STAFF RECOMMENDATION

737 Benton Avenue

June 15, 2016

Application: New construction – addition and outbuilding (DADU); Setback determination

garage - front elevation
1/8" = 1'0"

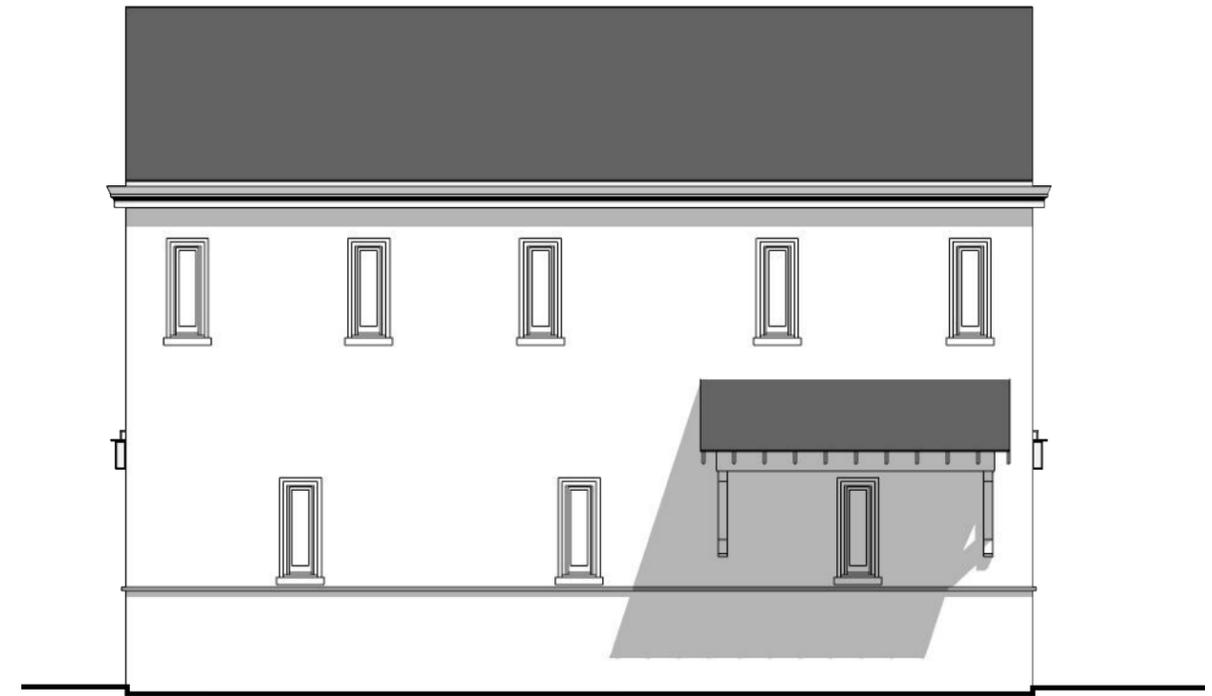
The footprint size, as well as the eave and roof heights of the outbuilding would be greater than the maximums permitted under section III.2.h of the design guidelines and the standards for detached accessory dwelling units outlined in 17.16.030.G of the Metro Code. The building is proposed to have even hundred square feet (700 sq. ft.) of living space, but that calculation does not include a two-hundred, ninety square foot (290 sq. ft.)

porch on the first story and three hundred, thirty square foot (330 sq. ft.) storage space on the upperstory. Although these spaces are not depicted as living space, Staff finds that they should be calculated as such because they are integral to the form and massing of the building; they are not like a simple entry porch and an attic, they are fully contained spaces within the footprint of the building, under the primary roof, and with full ceiling-heights.

Staff finds that scale and massing of the proposed outbuilding would not meet section III.2.h of the design guidelines and the standards for detached accessory dwelling units.

Staff recommends disapproval of the proposed outbuilding finding that it does not meet section III.2.h of the design guidelines and the standards for detached accessory dwelling units outlined in 17.16.030.G of the Metro Code.
